# DEVIATION REQUEST AND DECISION FORM

Project Name : Homestead North at Sterling Ranch Filing No. 3  
 Schedule No.(s) : 5228000030 and 5228000038  
 Legal Description : See Exhibit B – Legal Description

A deviation from the standards of or in Section **ECM section 2.3.2 Design Standards** of the Engineering Criteria Manual (ECM) is requested for the Poco Rd and Aspen Valley Intersection K value.

**ASPEN VALLEY ROAD PROFILE (3)  
STA 15+00.00 TO 18+29.41**

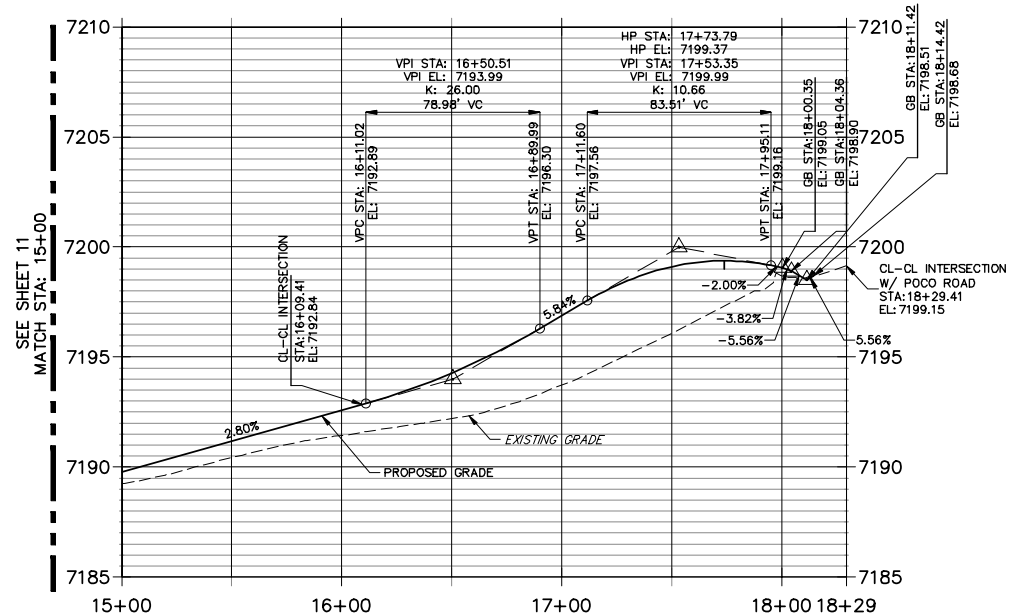
Per ECM Section 2.3.4, Table 2.12, a design speed of 25 MPH would require a K value of 12 on the Aspen Valley crest vertical curve approach to Poco Road.

Per the roadway design for Aspen Valley, the K value of the crest vertical curve is 10.66.

See Exhibit A for a representation of the Aspen Valley approach to Poco Road.

Aspen Valley Road is a urban local road providing Poco Road access to the residential lots within Homestead North at Sterling Ranch Filing No. 3. The natural topography of the area slopes south east which requires Aspen Valley Rd. to rise substantially to meet Poco Road existing grade. Poco Road is a rural road with roadside ditches and its drainage design is to keep the ROW stormwater flows draining east to Sand Creek. To maintain this drainage concept, a crest vertical curve was placed near the intersection. The proximity of the crest vertical curve to the intersection necessitated shorter vertical curve with a K value of 10.66 versus the ECM standard of 12.

The natural topography of the area slopes south east which requires Aspen Valley Rd. to rise substantially to meet Poco Road existing grade. Poco Road is a rural road with roadside ditches and its drainage design is to keep the ROW stormwater flows draining east to Sand Creek.

There is a 5.84% rising slope in Aspen Valley followed by a 2% downslope to Poco. The vertical curve was placed as close to the intersection as practical, to lessen the fill requirements.

Aspen Valley is stop controlled at Poco Road.

This request has been determined to have met the criteria for approval. A deviation from Section 2.3.2 of the ECM is hereby granted based on the justification provided.
